# Service instruction for EML224 Graphic systems with JB60N (Not N2 or CD) Electronic units.

19.2.09

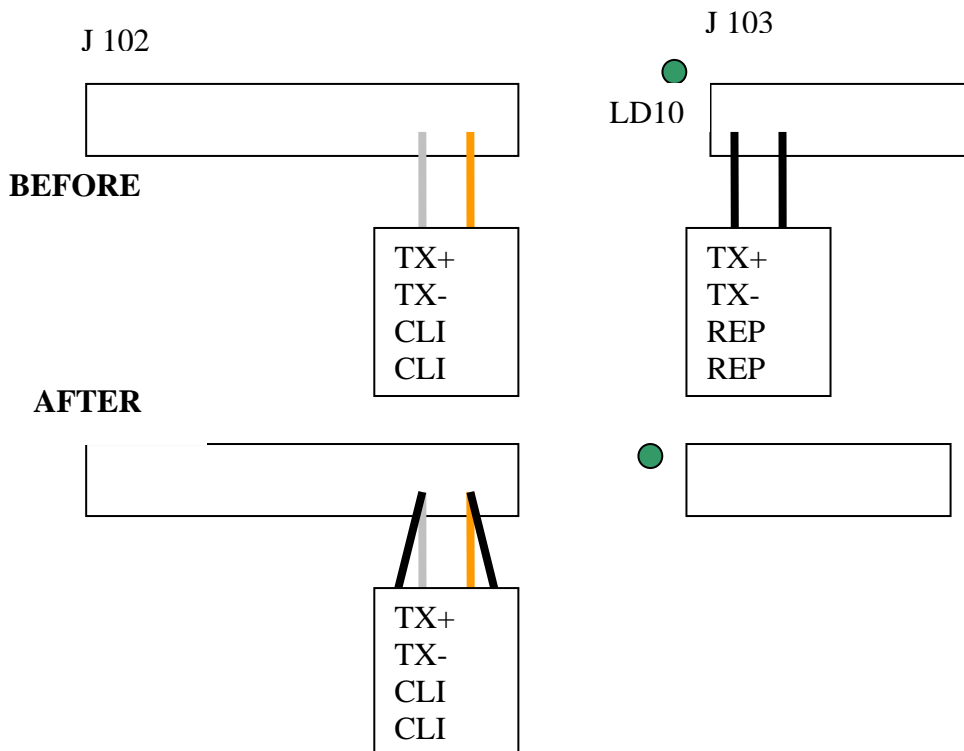
This unit has a diode LD 100 which indicates communication transmission, This loads the signal, weakening it over longer cables.

**Symptoms.** Communications stops from the sensor. But LEDS are lighting and power supply to sensor (J102 p 5 & 6 are ok >22V)

**Solution.** Bypass the LED by connection the J102 TX+ CLI and TX- CLI (white/orange or yellow/orange) to J103 TX+ REP and TX- REP (the Communication cable to the bridge unit).

SKIPPER Electronics have seen that this failure can occur after some time so we recomend all units to be wired in this way as a service task, or when retrofitting.
